I am writing to you as part of the Environmental Impact Statement (EIS) process for the Underground Bus and Train (BaT) project. I have worked in railway and Public Transport planning for most of the last 10 year and have spent quite some time reviewing the EIS documentation available for the BaT project.

Review of the Underground Bus and Train (BaT) project EIS

Figure 3: Bus volume vs Road capacity in 2021

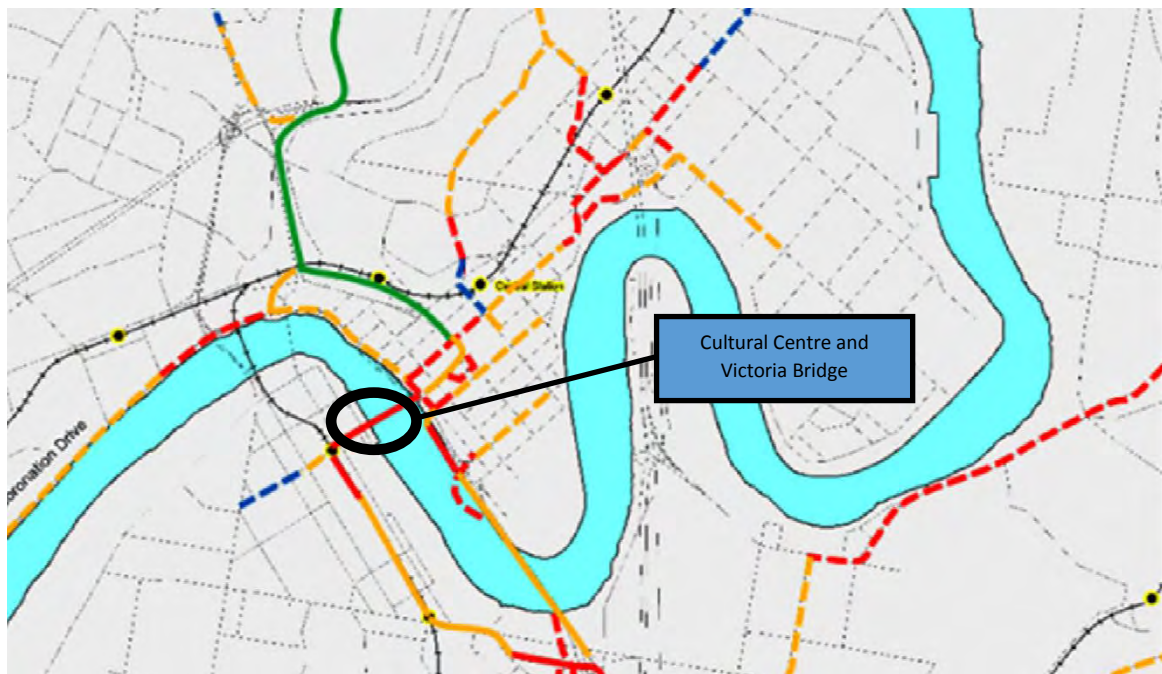
The volume of buses around the Cultural Centre and Victoria Bridge is well over the theoretical capacity of the road in this area. This is leading to lengthy delays on the Busway inbound in the morning peak and on the Victoria Bridge/North Quay area in the afternoon peak.

Looked at in isolation this congestion of buses would seem to support the need for additional infrastructure to alleviate the congestion in this area.

Indeed, the EIS attempts to lead you to this conclusion. However, this conclusion is wrong.

Figure 5: Intersections on the Northern Busway

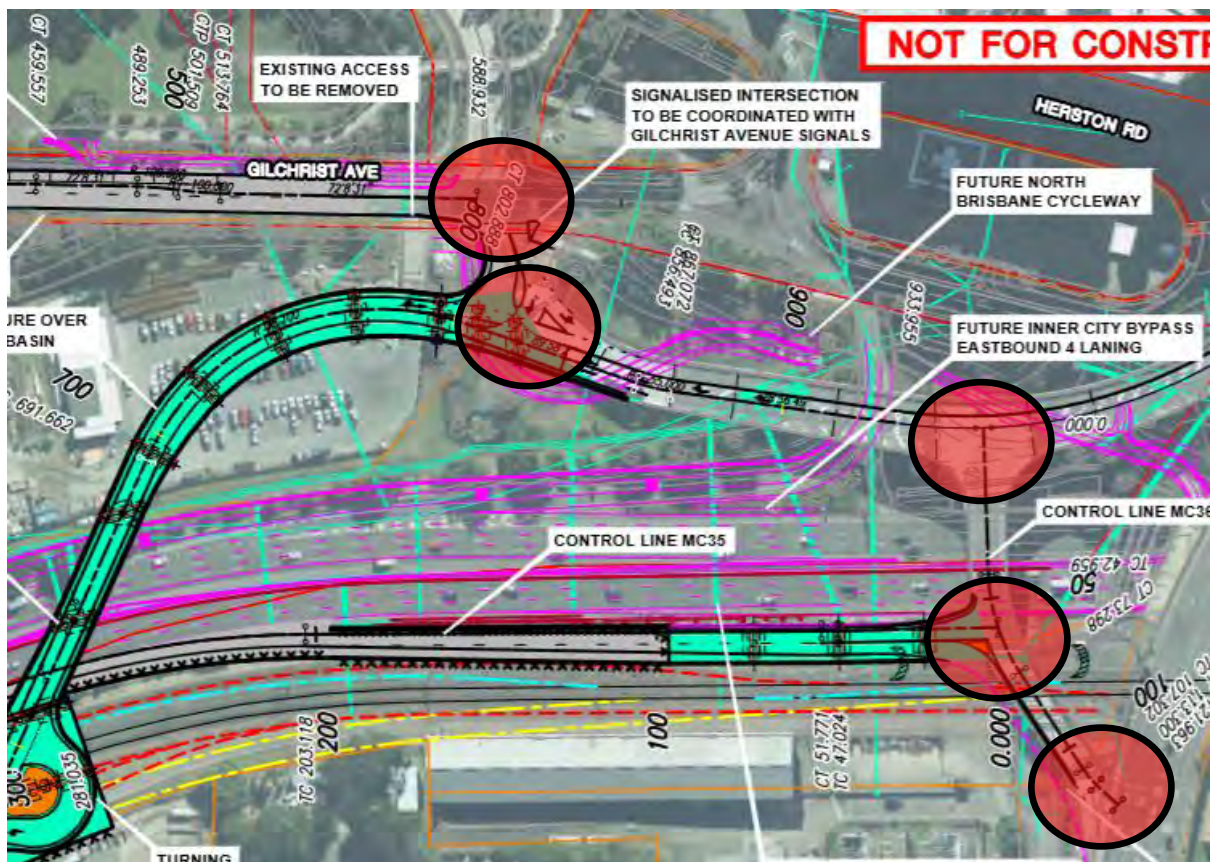
Issue 8: The project has introduced additional intersections onto the northern busway and failed to model the impacts.

The connection between the project and the Northern busway has results in 3 intersections on the busway within close proximity to each other and another two intersections to access the ICB or Bowen Bridge road. These intersections are shown in Figure 5 below.

The report does not detail the bus flows through these areas or the impact of these intersections on capacity and travel times.

This area should be of particular concern as during the morning peak it will have a high bus flows in both directions because it will handle peak buses approaching the city from the north as well as all of the buses that have come through the BaT tunnel from the south and buses heading north from King George Square on the existing Inner-Northern Busway.

This means that the area will effectively be handling peak period numbers of buses in both directions at the same time.

Having high bus flows in both directions combined with multiple intersections on the Busway should raise significant concerns about how well this area of the network will function. Failing to calculate the bus flows through this area and model the effectiveness of these intersections is simply not good enough for this kind of project.

Figure 6: Model performance showing limit of modelling at Ormeau

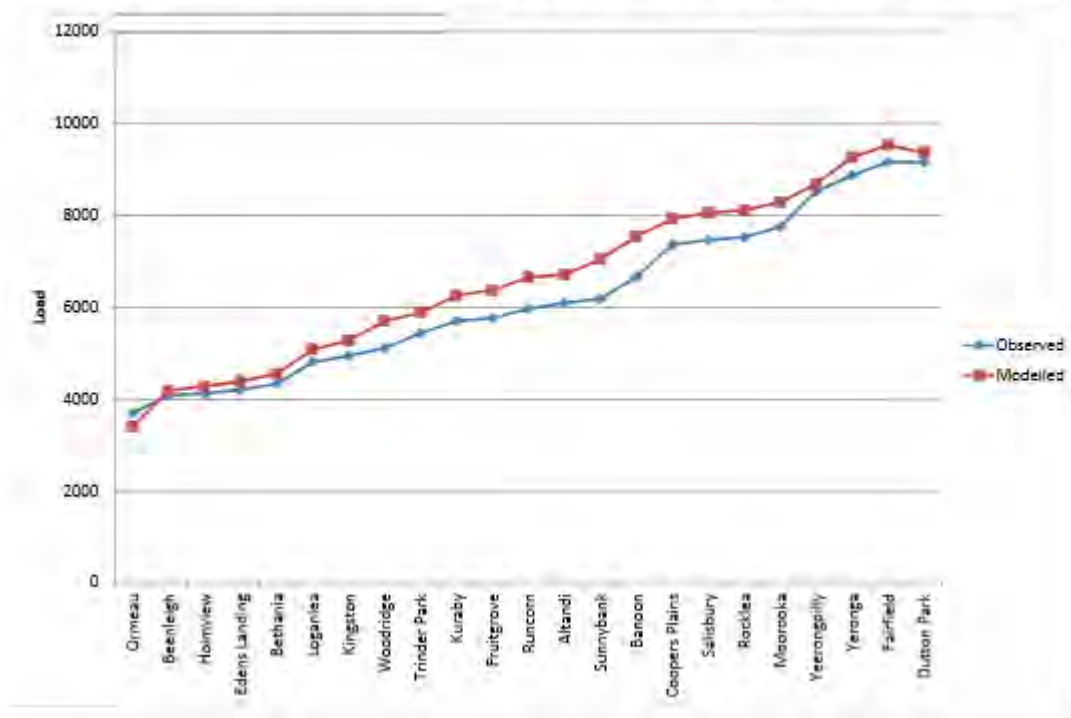
Issue 9: The modelling area does not extend to the southern end of the Gold Coast rail line.

The modelling of the Gold Coast area is a key concern as crowding on the Gold Coast line was identified as one of the key reasons for needing additional rail capacity from the southern lines.

The Technical Transport Report, page 21, provides a diagram clearly showing that the modelling only extends as far south at Ormeau station – missing Coomera, Helensvale, Nerang, Robina and Varsity Lakes station. This diagram is shown below in Figure 6.

There are no forecasts of the boardings, alightings or demand growth from the Gold Coast stations included in the EIS.

The lack of such forecasts is inexcusable as the crowding on the Gold Coast services was a key reason that additional inner-city capacity is required.
